# FISHER SERVICE BULLETIN

ADDENDUM TO RC-75 SERVICE MANUAL

SUBJECT: CONVERSION TO 220 VOLTS, 50 - 60 Hz OPERATION

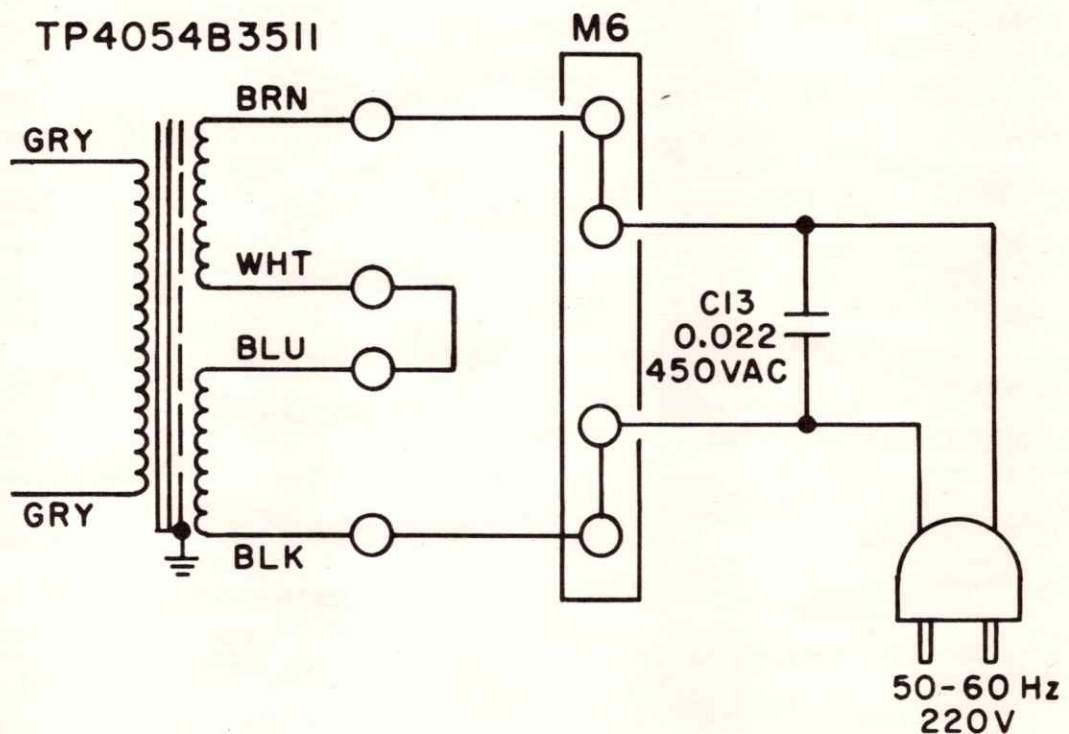
To convert the RC-75 Tape-Cassette Recorder from 120 volts, 50 to 60 Hz to 220 volts, 50 to 60 Hz operation, connect the power transformer as shown below.
